The enclosed Traffic Impact Study (TIS) review letter for the **Grey Wolf Meadows** (Tax Parcels: 334-10.00-23.00, 334-10.00-23.01) mixed use development has been completed under the responsible charge of a registered professional engineer whose firm is authorized to work in the State of Delaware. They have found the TIS to conform to DelDOT's Development Coordination Manual and other accepted practices and procedures for such studies. DelDOT accepts this letter and concurs with the recommendations. If you have any questions concerning this letter or the enclosed review letter, please contact me at [Annamaria.Furmato@delaware.gov](mailto:Annamaria.Furmato@delaware.gov).

RE: Agreement No: 2138S  
TIS Support Services – T202369005  
Task Name: Task 1-7 Grey Wolf Meadows  
JMT No.: 24-01365-107

Johnson, Mirmiran, and Thompson (JMT) has completed a review of the Traffic Impact Study (TIS) for the Grey Wolf Meadows development, which was prepared by Pennoni Associates Inc. dated May 9, 2025. This review was assigned as Task Number 1-7. The report is prepared in a manner generally consistent with DelDOT's *Development Coordination Manual* and other Department standards.

## Recommendations Map

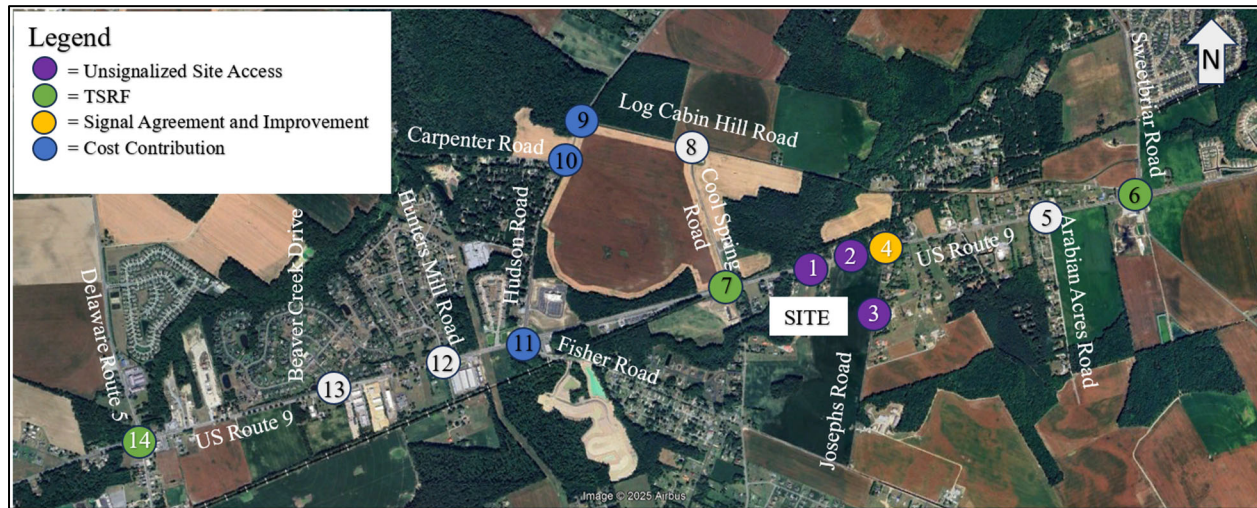
#### 4 – US Route 9 / Josephs Road (See Table 5, Page 31, Development Improvement #5 & 6)

The two-way stop-controlled intersection of US Route 9 and Josephs Road would exhibit LOS deficiencies along the northbound Josephs Road minor approach during all peak hours under future conditions with or without the proposed development (Case 2 & 3). The intersection would also exhibit LOS deficiencies along the southbound Josephs Road approach during the PM peak hour under future conditions without the proposed development (Case 2) and during all peak hours under future conditions with the proposed development (Case 3). Specifically, under Case 3 conditions during the PM peak hour, the northbound and southbound Josephs Road approaches would operate at LOS F with a delay of over 1,000 seconds per vehicle.

The deficiencies could be mitigated by the provision of a traffic signal or a multi-lane roundabout. However, a multi-lane roundabout would require widening along US Route 9 to accommodate the additional lanes through the roundabout. The additional through lanes would either need to be continued along US Route 9, resulting in significant geometric impacts, or dropped locally at the intersection. A local drop may result in uneven lane utilization which would impact operations at the roundabout and may potentially create safety concerns with the merge condition created by the lane drop. Additionally, widening to provide two through lanes in each direction along US Route 9 would have geometric impacts to properties and utilities near the intersection.

JMT performed a Traffic Signal Justification Study (TSJS) at the intersection. Based on a review of the traffic signal warrants from the 2018 Edition of the Delaware Manual on Uniform Traffic Control Devices (DEMUTCD), the volume warrants are met under future conditions with the proposed development (Case 3). Based on the results of the TSJS, a traffic signal is recommended at the US Route 9 and Josephs Road intersection. Additionally, to reduce projected queue lengths along US Route 9 as a result of signalization, it is recommended that the intersection be coordinated with the adjacent signalized intersections along the corridor. The developer should enter into a signal agreement with DelDOT and install the recommended lane configurations for potential future signalization of the intersection.

### 3 - Site Entrance C/ Josephs Road (Sussex Road 281) (See Table 4, Page 30, Development Improvement #4)

proposed two-way stop-controlled intersection would operate at acceptable LOS under future conditions with the proposed development. However, DelDOT requested the consideration of a single-lane roundabout to be utilized as a traffic calming measure to address speeding along the corridor. With the implementation of a single lane-roundabout, the proposed site access would operate at acceptable LOS A with a delay of approximately 3.6 seconds per vehicle.

Additionally, the developer should consider relocating Site Entrance C access to be directly across from Foxfield Lane.

2. The developer should construct an unsignalized Site Entrance A rights-in/rights-out only access for the proposed Grey Wolf Meadows development along US Route 9, approximately 1,000 feet west of the intersection with Josephs Road. The intersection should be consistent with the lane configurations shown in the table below:

- The developer should construct an unsignalized Site Entrance B rights-in/rights-out only access for the proposed Grey Wolf Meadows development along US Route 9, approximately 400 feet west of the intersection with Josephs Road. The intersection should be consistent with the lane configurations shown in the table below:

- The developer should construct an unsignalized Site Entrance C full access for the proposed Grey Wolf Meadows development along Josephs Road, approximately 600 feet south of the intersection with US Route 9. The intersection should be consistent with the lane configurations shown in the table below:

- The developer should improve the US Route 9 and Josephs Road intersection to add left turn lanes and be consistent with the lane configurations shown in the table below:

- The developer should enter into a traffic signal agreement with DelDOT for the intersection of US Route 9 and Josephs Road. The developer should coordinate with DelDOT Development Coordination Section to execute the traffic signal agreement.
- The developer should enter into an agreement with DelDOT to contribute to the Traffic Signal Revolving Fund (TSRF) for the intersection of US Route 9 and Sweetbriar Road/Dairy Farm Road. The contribution amount is \$13,268.18.
